CITY OF ALBUQUERQUE

Re: United Poly Systems Bldg. Addition
5201 Hawking Dr. SE Albuquerque NM 87106
Traffic Circulation Layout
Engineer's/Architect's Stamp 05-25/2015 (Q16DA5000)

SITE PLAN

United Poly Systems - Building Addition
5201 Hawking Dr SE
Albuquerque, NM 87106

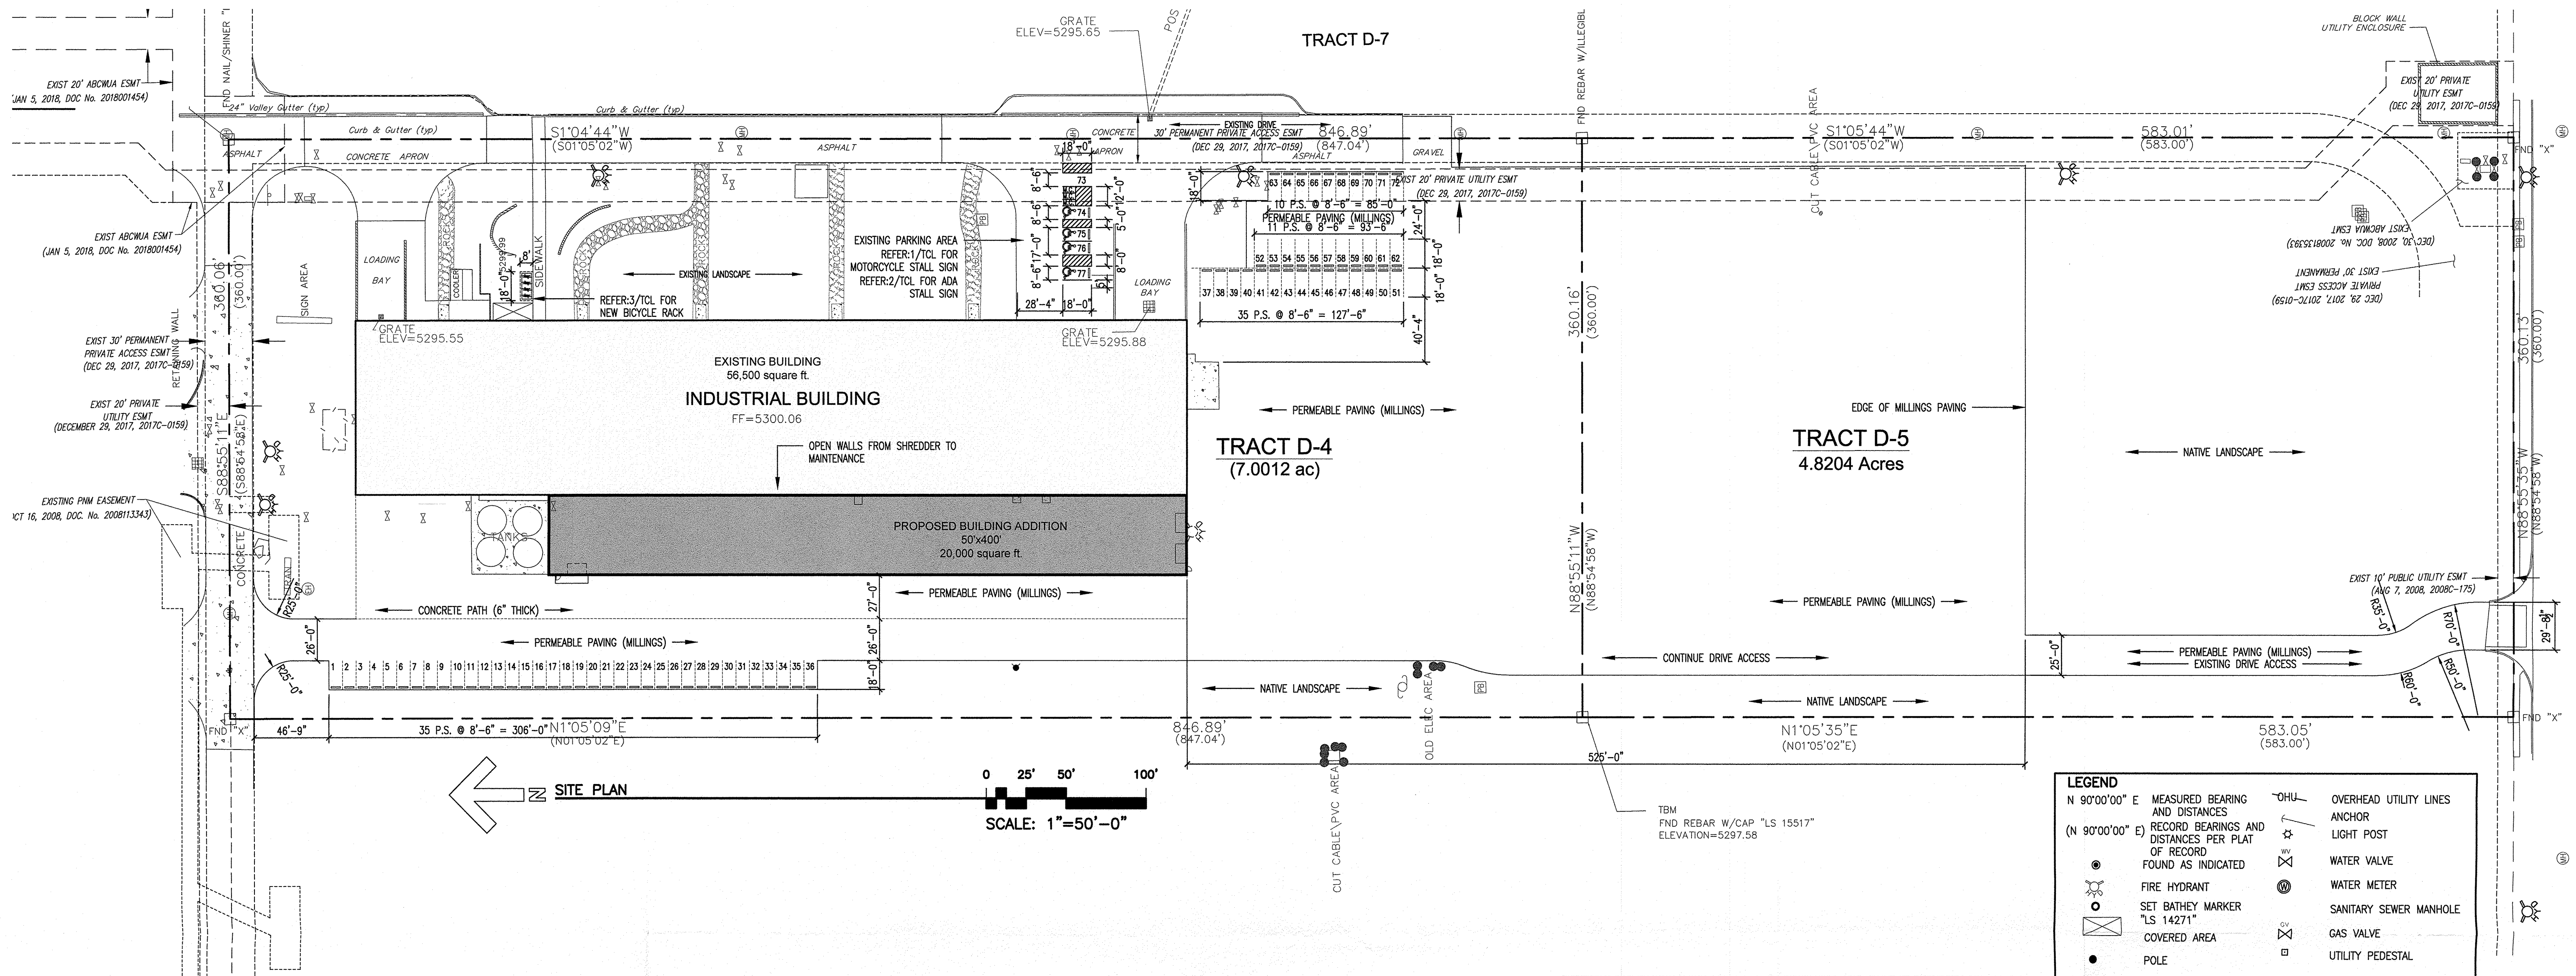
The TCL submittal received 05-29-19 is approved for Building Permit **with a condition of providing a copy of refuse approval at the time of CO**. A copy of the stamped and signed plan will be needed for each of the building permit plans. Please keep the original to be used for certification of the site for final C.O. for Transportation.
